TECHNICAL SERVICE BULLETIN

Bulletin No.: TSB-034

Subject: Cylinder Collar Bolt Replacement

Models: Select 3600 PSI Quantum Virtual Pipeline Trailers

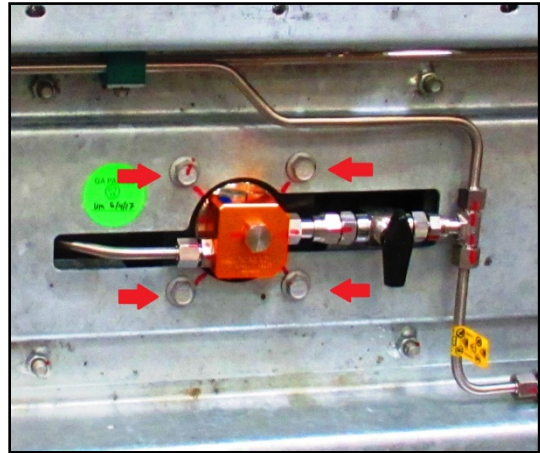
Some Quantum VP trailers have been found to have the upper cylinder support collar fasteners to be loose or broken.

The finish on the cross members used in some of the Quantum VP trailers can have an effect on the ability of the upper cylinder support collar fasteners to retain torque. The finish can creep from under the head of the bolt over time, which can result in a loss of torque on the fastener.

Upper Cylinder Collar Fastener Replacement

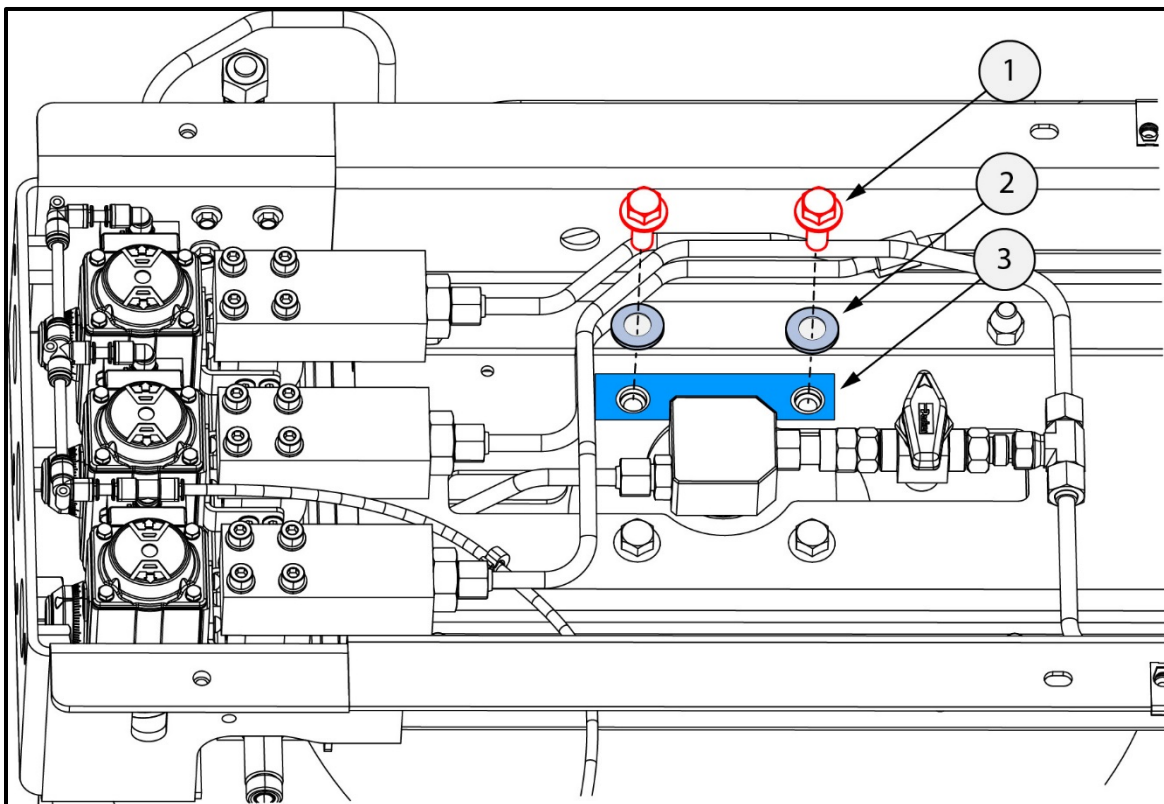
A new fastening technique has been developed to help distribute the load to reduce the effect of the cross member finish. In addition a new longer bolt was added to accommodate the addition of a locking washer.

1. Remove two of the bolts (1) retaining the upper cylinder collar and discard.
2. Place the bolt plate (3) in position as shown.
3. Install lock washers (2) on two new bolts (1) and hand start. Make sure the washer is oriented as shown in the picture.
4. Tighten the upper collar bolts to 66 lb.ft. (90 N.m.).
5. Repeat steps 1-4 for the other two upper collar mounting bolts.
6. Repeat this procedure for every cylinder in the affected trailers.
